ORIGINATION FORM

Proposed Revisions to a Standard Plans Index

Index Number: 515-022

Index Title: Pedestrian/Bicycle Bullet Railing Details

**SHEET
3 of 3**

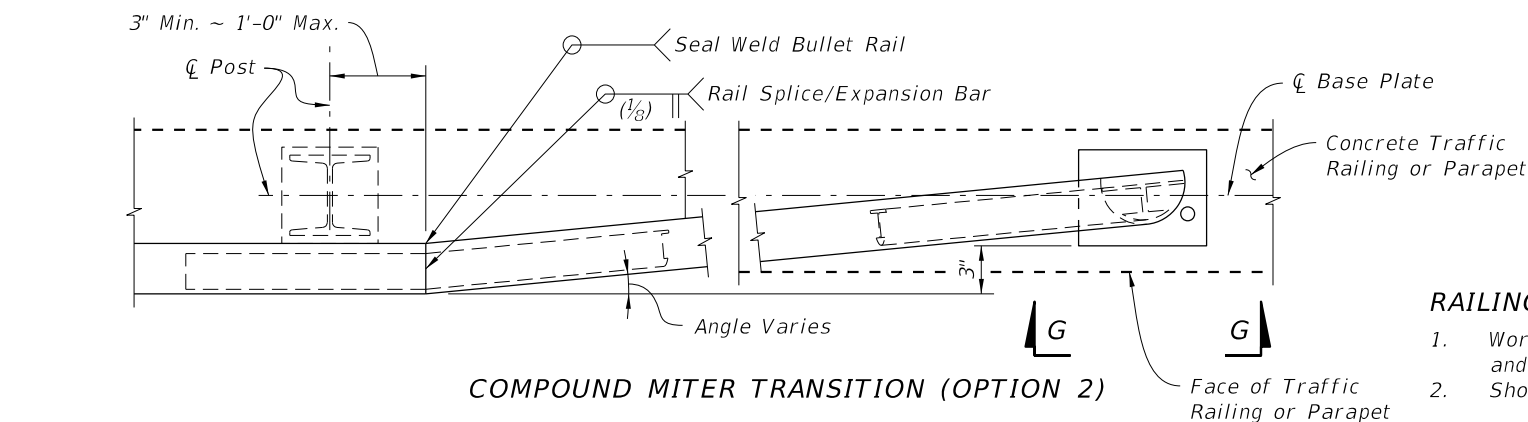
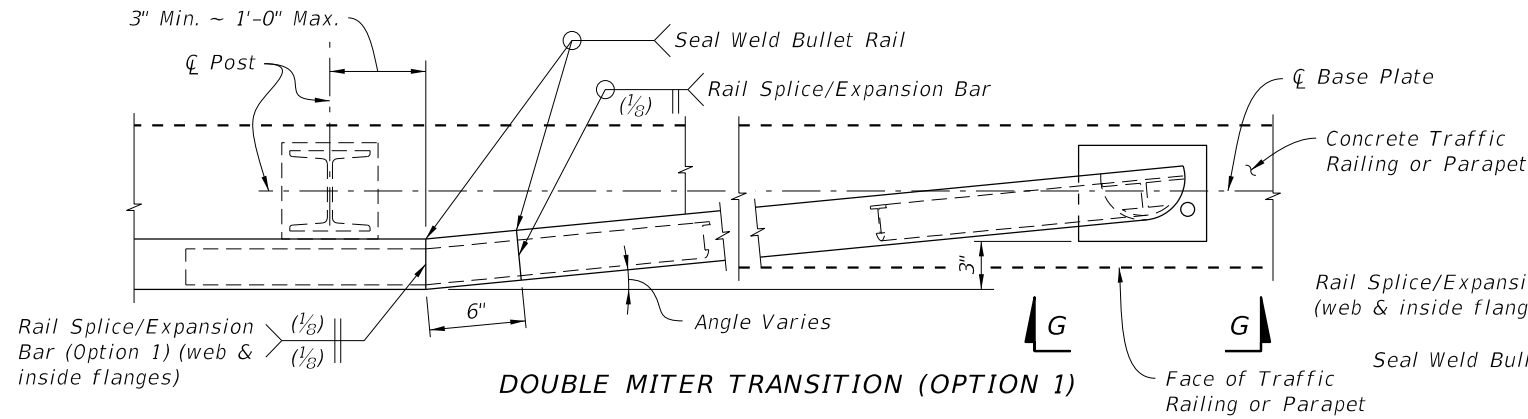
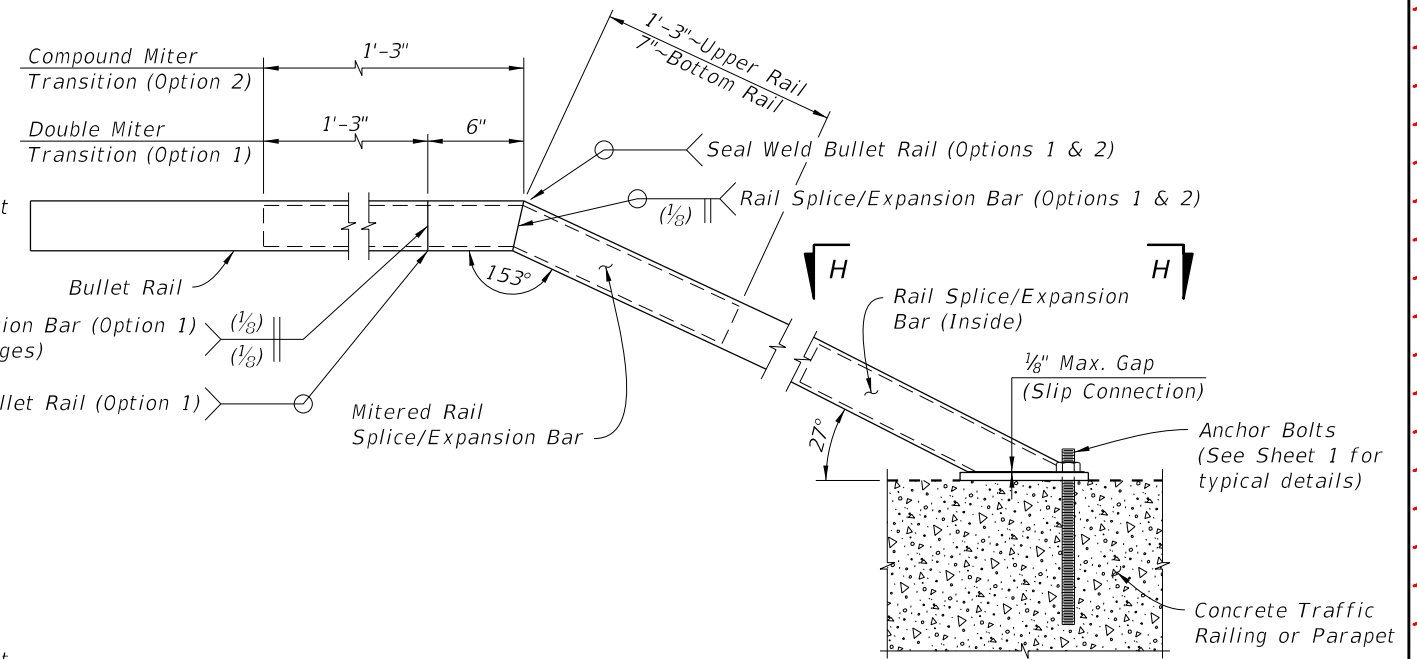
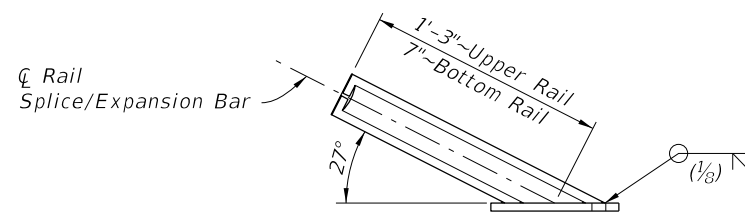
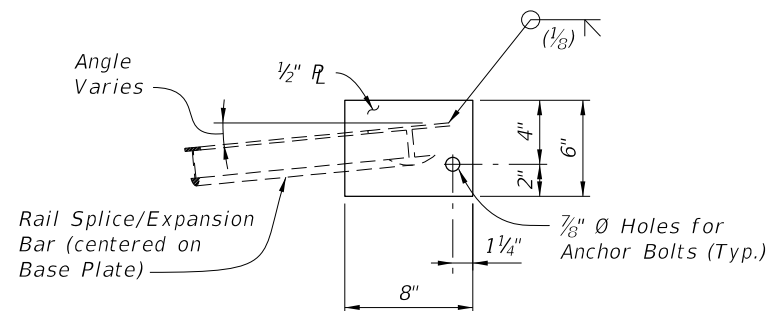
Sheet 3: Corrected the relative location and dimensions of the base plate and post with respect to the edge of the bullet rail.

Dimensions and drafting associated with the rail were corrected to reflect its correct orientation. The rail had been drafted as if it were facing down in plan which was incorrect.

Edited details to correct the orientation of the rail.
